Municipal Planning Commission
Regular Meeting

February 8, 2024
4:00 PM

- 2024-MPC-03 : Upper Gilchrist RD Parcel #71-00050.000 - Comprehensive Development Plan

**2024-MPC-03 : UPPER GILCHRIST RD PARCEL #71-00050.000 - COMPREHENSIVE
 DEVELOPMENT PLAN**

MT. VERNON
KNOX COUNTY, OHIO
PRELIMINARY LANDSCAPE PLAN

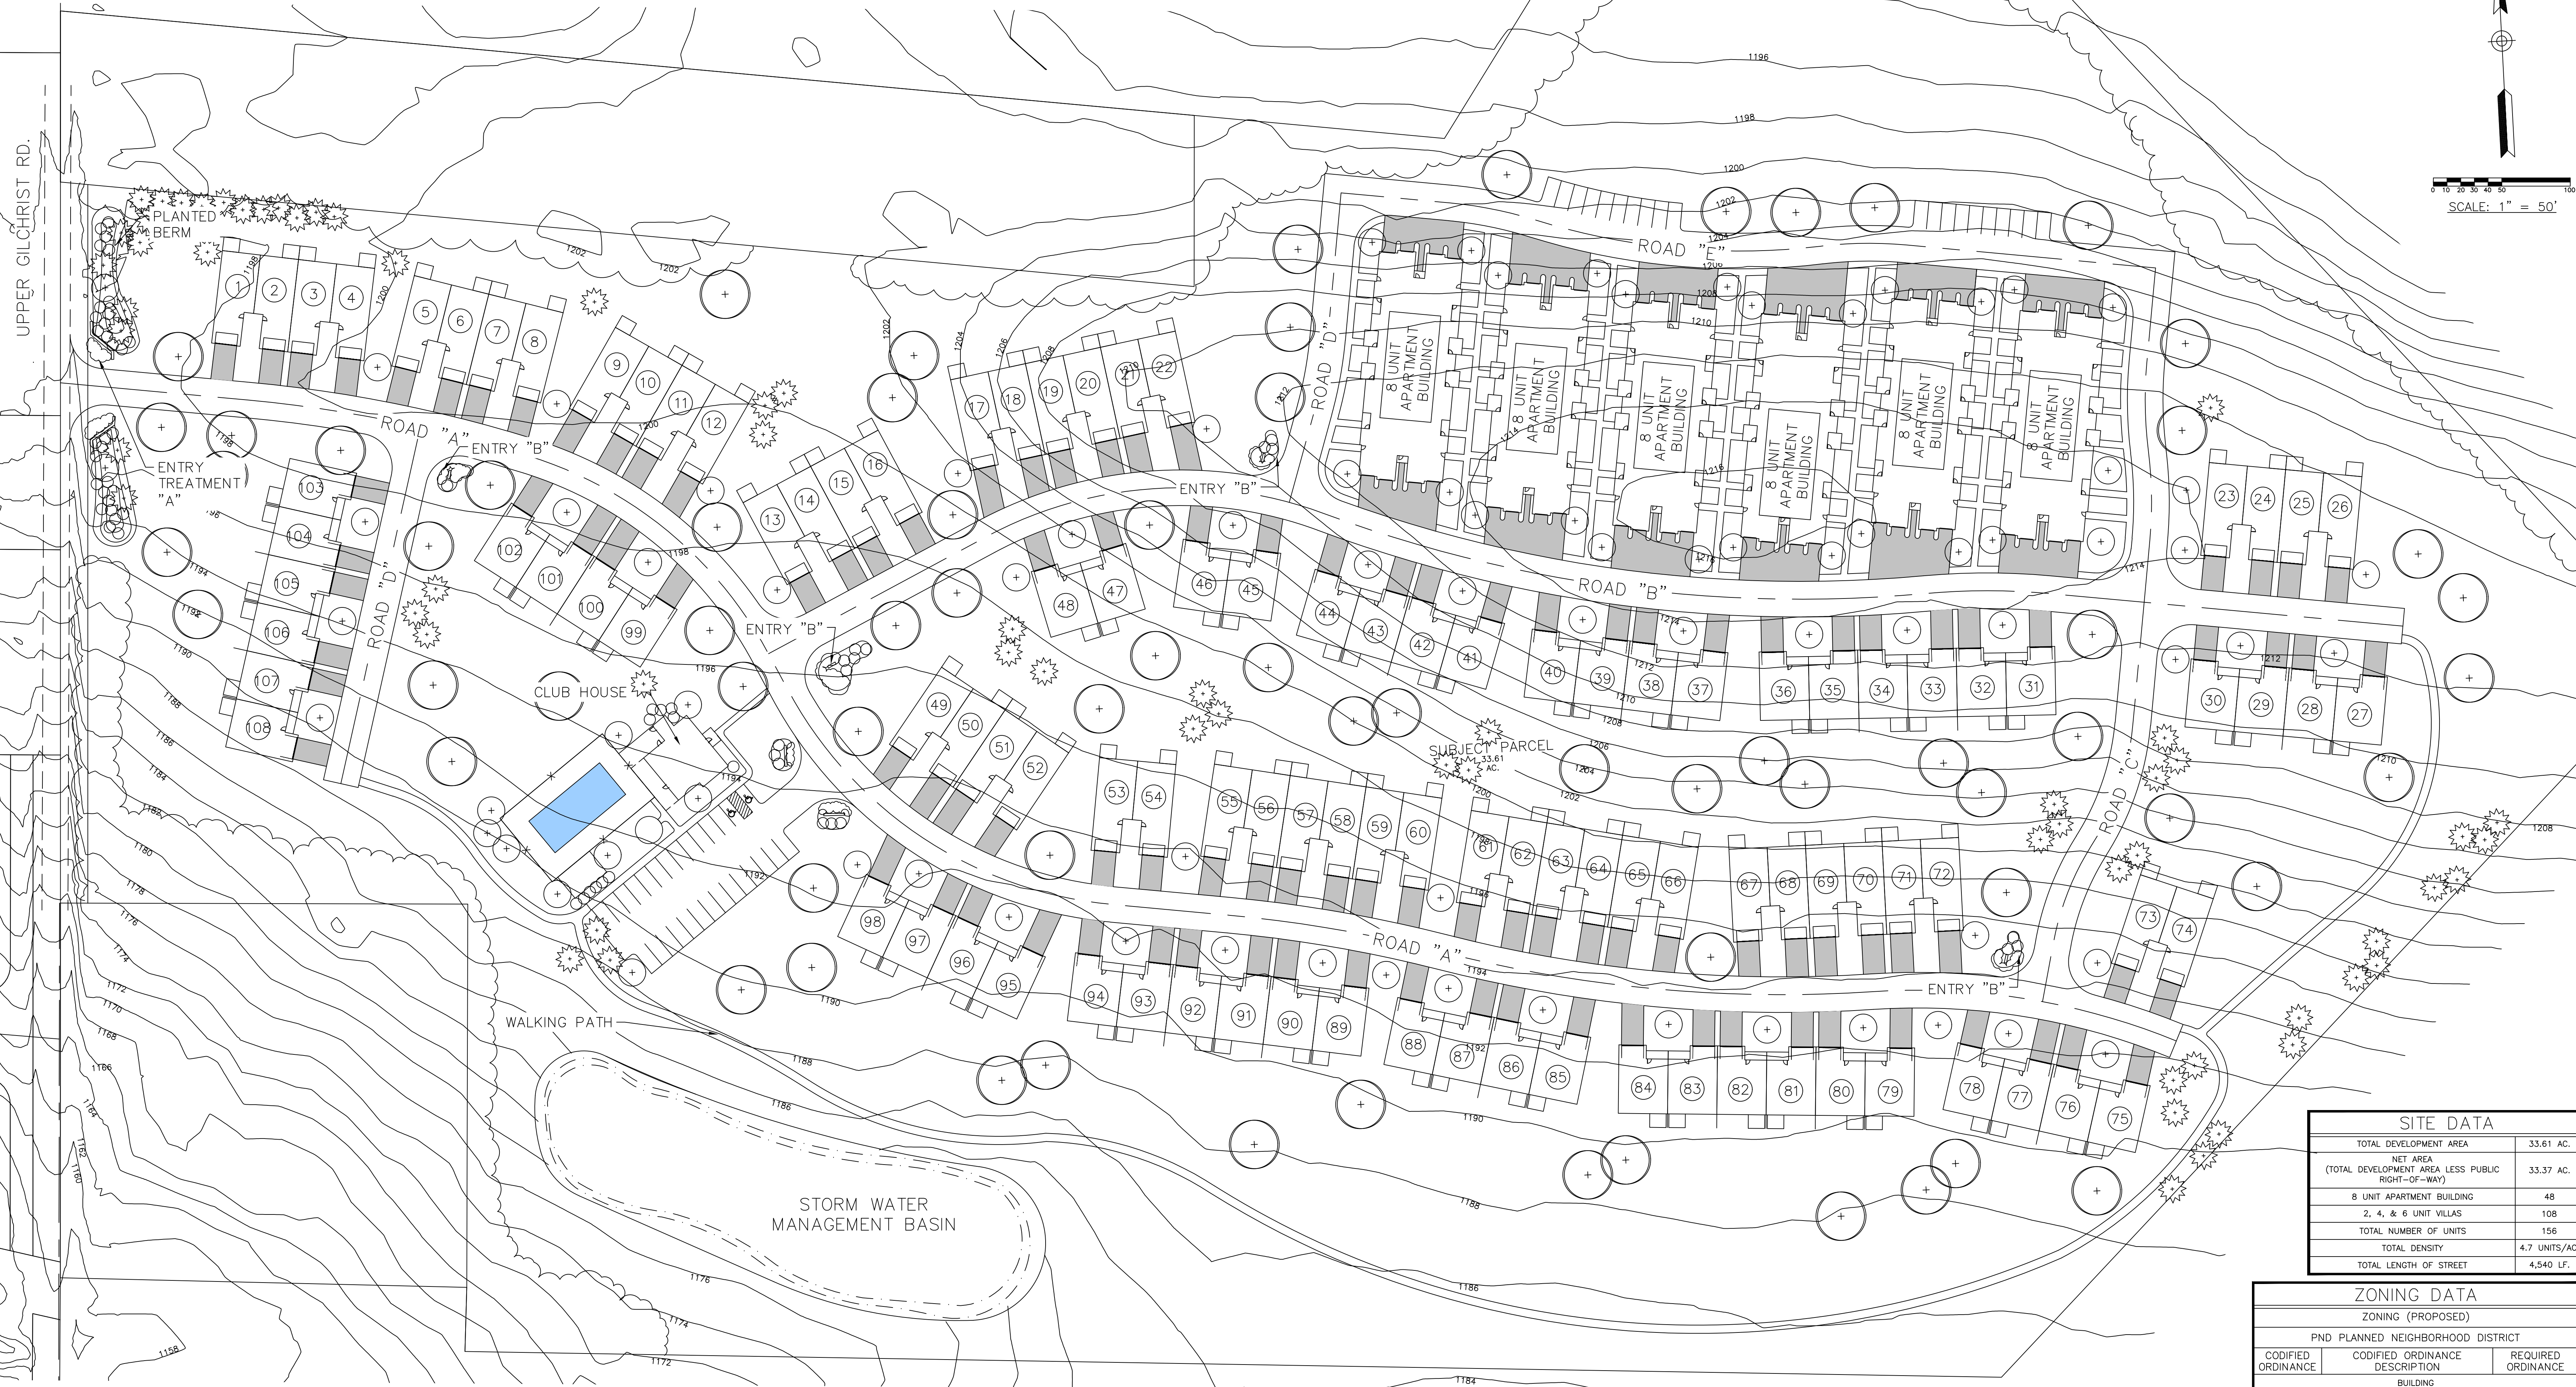
Salyers said during the rezoning process a neighbor expressed concern about light pollution. Mackie said the landscaping plans show considerable buffering, specifically for the residents that expressed concern during the rezoning process. There is a lot of space around the perimeters and a stormwater basin was added on the north side. The landscaping plan was displayed. Starr asked Ball if these plans have been submitted to the Shade Tree Commission. Ball said this development is not required to submit plans to the STC because they are not platting a public street or subdividing the land. The plan does have a good number of trees. Without counting the trees, it would probably meet the rules if they were platting a road.

C. Pido (sworn in) spoke in agreement with Stulka, stating she and her husband purchased their land seeking privacy. She said she understands growth and development and revenue. She asked for consideration to plant a double layer of pine trees along the property lines to reduce noise, instead of shade trees.
